TO: Mercedes-Benz Dealer Principals, General Managers, Sales Managers, Service Managers, Parts Managers	FROM: Michael Scott, DM Regulatory Management and Campaigns
RE: Recall Campaign Launch Notification MY15 - MY17 447 (Metris) Mercedes-Benz Transmission Carrier Attachment	DATE: June 21, 2018

Campaign No. 2018060012, June 2018

SUBJECT: **Model 447 (Metris), Model Year 2015 - 2017
Transmission Carrier Attachment**

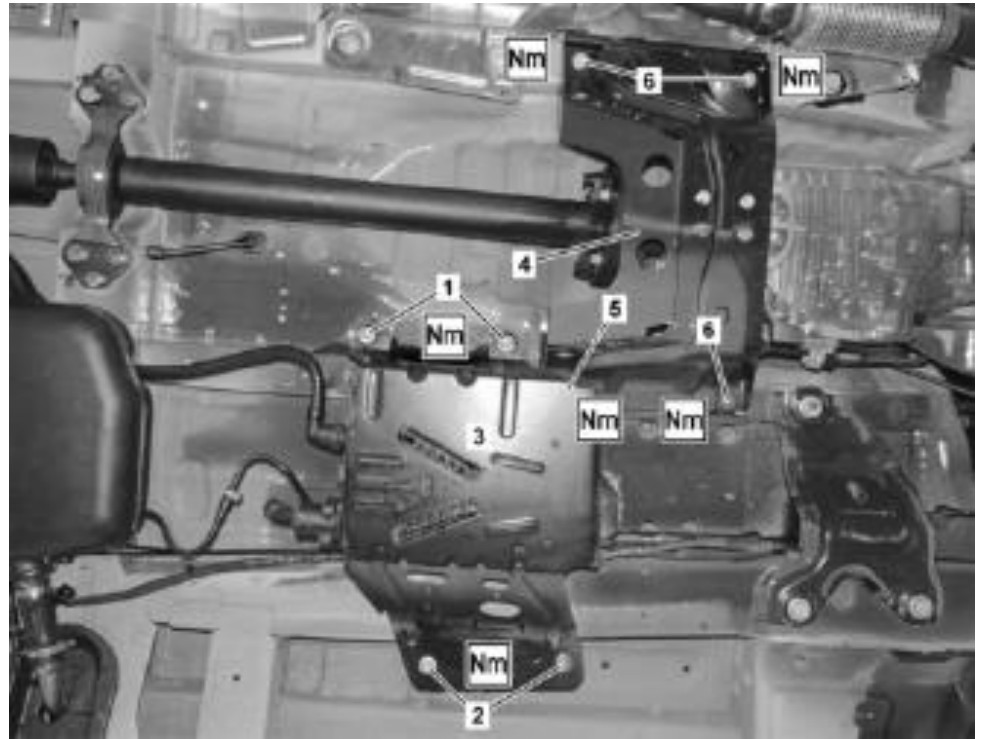
Daimler AG, the manufacturer of Mercedes-Benz Metris vehicles, has determined that in certain vehicles (Platform 447), the screw connection of the transmission carrier to the vehicle body may not be tightened with the specified torque. If the screw connection of the transmission carrier is not sufficiently torqued, the bolts could loosen and subsequently lose connection with the vehicle. In that event, the position of the transmission carrier and the angle of the propeller shaft to the transmission could change. If this angle exceeds a certain degree, the joint disc could be damaged and lead to its complete failure. The customer will be alerted to clear warning signs of vibrations and rattling noises during operation of the vehicle prior to such loss of power. In this case, the vehicle would remain controllable (steering and braking would not be affected). However, an increased risk of a crash cannot be ruled out. An authorized Mercedes-Benz dealer will perform a check of the bolts on all potentially affected Metris vehicles and replace the bolts if necessary.

Check		
1	Check whether vehicle is affected by measure.	i For authorized Mercedes-Benz service partners, only the entry in the "Extended VEGA Application" (EVA) system, in the "Current" tab is decisive. An additional test of the affected vehicles in the workshop information system (WIS) or in the vehicle list is thereby not necessary.
Remove		
2	Raise vehicle.	
3	Remove bolts (1) of activated charcoal canister holder (3).

4	Unfasten bolts (2) of activated charcoal canister holder (3) by a few turns.	Do not stretch electric lines as well as hoses and lines of activated charcoal canister. Damage may occur otherwise. i To gain access to the bolt (5), release bolts (2) only. The bracket for the activated charcoal canister (3) remains mounted to the vehicle.
Check		
5	Check torque of bolts (5, 6) of transmission carrier (4).	When checking the torque none of the bolts (5, 6) may turn before the torque value is reached. If one of the bolts (5, 6) turns replace it. Otherwise, the correct tightening torque for the respective bolts (5, 6) cannot be assured. Nm Bolt, transmission carrier to longitudinal member If bolts (5, 6) turn before the torque value is reached. ↓ Replace relevant bolts (5, 6).
Install		
6	Screw bolt (1, 2) into activated charcoal canister holder (3).	Nm M8
7	Lower vehicle.

Number	Designation		Model 447 with engine 274, 651 Model 448 with engine 274
BA22.10- N-1002-01EE	Bolt, transmission carrier to longitudinal member	Nm	58

Part no.	Designation
N 910143 010012	Bolt for transmission carrier on longitudinal member M10x30
